Ohio Imaging
Nuclear Medicine Division

April 4, 1995

In response to your letter of March 15, 1995 referencing our application dated February 14, 1995, requesting a device evaluation for the registration of the model STEP transmission line source holding device of our manufacture, please accept the following supporting information in the order requested:

Figure 1-1

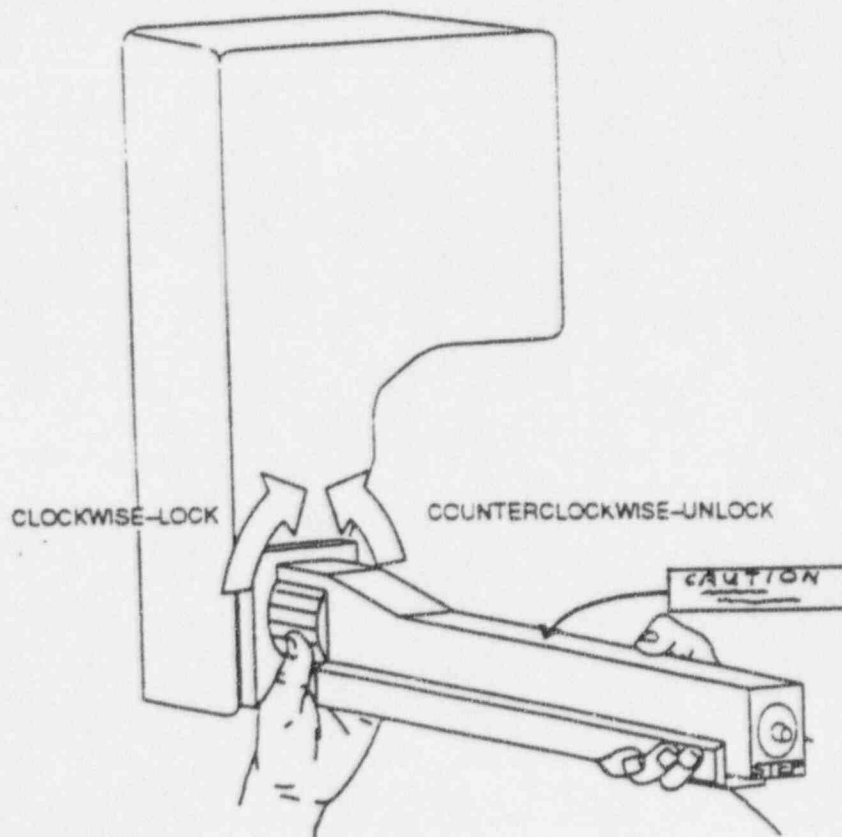
Proposed wording on a label to be applied to the smooth top surface of the source holder as shown on Page 1-3 of the Operator's Guide.

Contains:		Gd-153, Maximum 75mCi	CAUTION RADIOACTIVE MATERIAL	
	or	Co-57, Maximum 25mCi		
	or	Tc99m, Maximum 20mCi		
Refer to STEP Operator's Guide for safe handling instructions				
The U.S. Nuclear Regulatory Commission has approved distribution of this STEP Device to persons licensed to use byproduct material identified in 10CFR 35.87 or persons who hold an equivalent license issued by an agreement state.
